Planning Board Agenda

A. PUBLIC HEARING FOR MOUNTAIN VIEW SUBDIVISION CONTINUED

STAFF REPORT Mountain View Subdivision

Figure 1. Development Plan

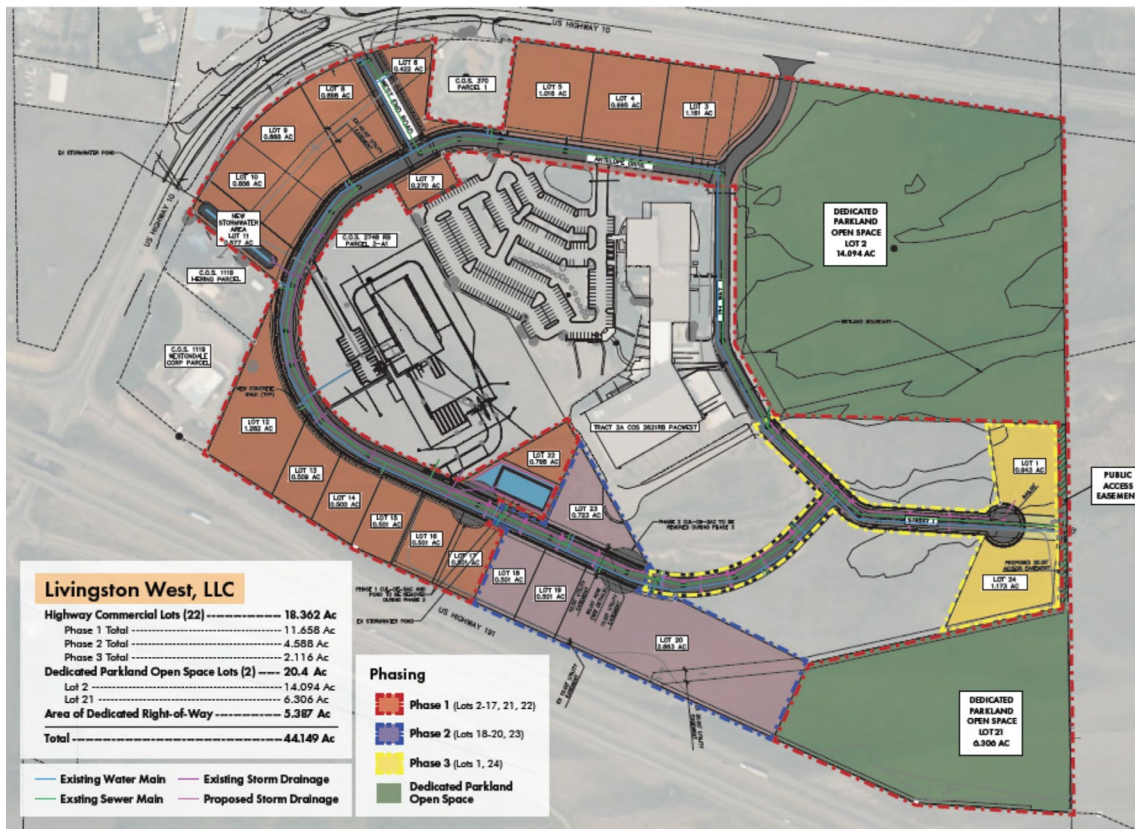
Livingston Public Works- comments were provided about the following: additional costs to the City associated with the proposed subdivision; street improvements and temporary safety measures between phase development; erosion control; water and sewer connection requirements for each subdivided lot; ownership and maintenance responsibilities for new public facilities; and staff review of stormwater and street plans for phases 2 and 3. Recommendations were made for: a new sewer main near Kenyon Noble as recommended in the Wastewater Preliminary Engineering Report;

POA covenant revisions; a water and sewer easement across Lot 12 for future services to an adjacent parcel.

An all-weather access road between Antelope Drive and PFL Way must be constructed as part of Phase 1 improvements to provide maintenance and emergency access until future phases and streets are constructed to complete the internal road network. The Public Works director has requested the applicant provide dead end barricades at the cul de sacs for each phase of development to prevent the public from accessing the all-weather road.

12. The applicant must install provide dead end barricades at the cul de sacs for each phase of development to prevent the public from accessing the all-weather road.

13. An all-weather access road between Antelope Drive and PFL Way must be constructed as part of Phase 1 improvements to provide maintenance and emergency access until future phases and streets are constructed to complete the internal road network.
